DART SERVICE INSTRUCTION

TO AMEND INSTALLATION INSTRUCTIONS IIN-D119-646 REV. B
AND INSTRUCTIONS FOR CONTINUED AIRWORTHINESS ICA-D119-646 REV. 1
REF. FAA STC: SR02024SE
REF. EASA STC: 10040294

FIGURE 1: BOLT SUBSTITUTION

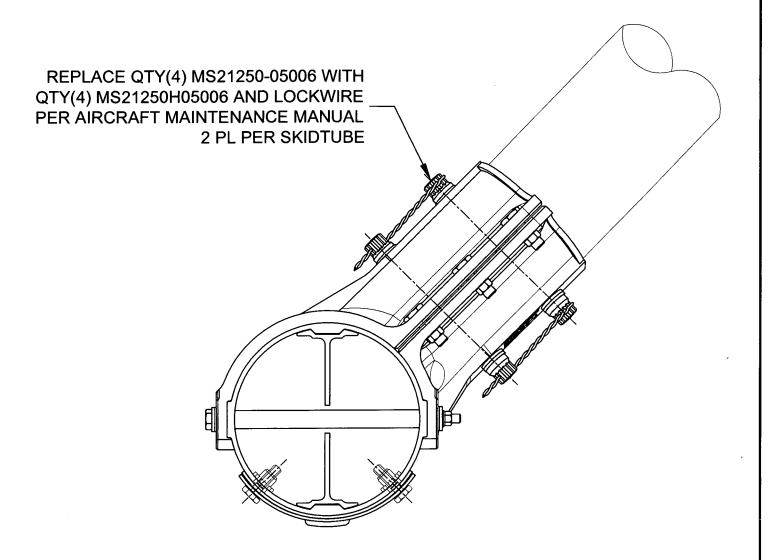
To provide an alternate fastening method to secure the D119-646-XXX skidtubes to the aircraft crosstubes

The MS21250-05006 Bolts can be replaced with MS21250H05006 and lockwired with MS20995C47 (customer supplied) in accordance with MS33540 or AC 43.13. Refer to Figure 1 of this service instruction for reference. The torque on the MS21250H05006 should be limited to 65-85 in-lbs (7.3-9.6 N-m).
